MONTICELLO NUCLEAR GENERATING PLANT
Docket No. 50-263 License No. DPR-22

License Amendment Request Dated March 21, 1978

REQUEST FOR AMENDMENT TO
OPERATING LICENSE NO. DPR-22

PROPOSED CHANGES TO TECHNICAL SPECIFICATIONS

Figure 3.11.1-B

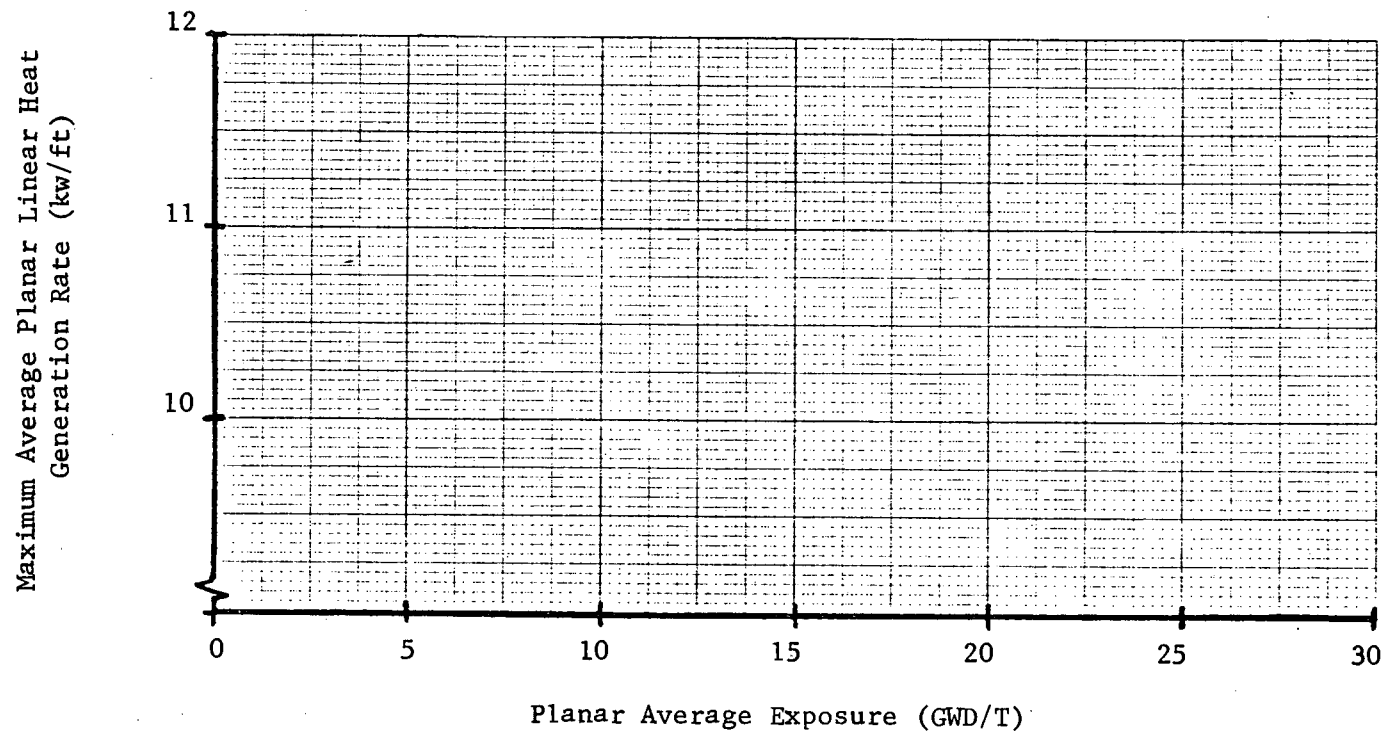
Page vii. Modify the title of Figure 3.11.1-B and add a new Figure 3.11.1-Ba as shown in Exhibit B.

The Technical Specifications presently include a MAPLHGR limit for 7D230 fuel, a fuel type that is not expected to be used at Monticello in the future. MAPLHGR limits are therefore eliminated for 7D230 fuel. That page is replaced with limits for a new fuel type, 8DR 264. Limits for the other new fuel type, 8DR 282, are on a newly created page.

Calculated Results to
be provided at a later
date
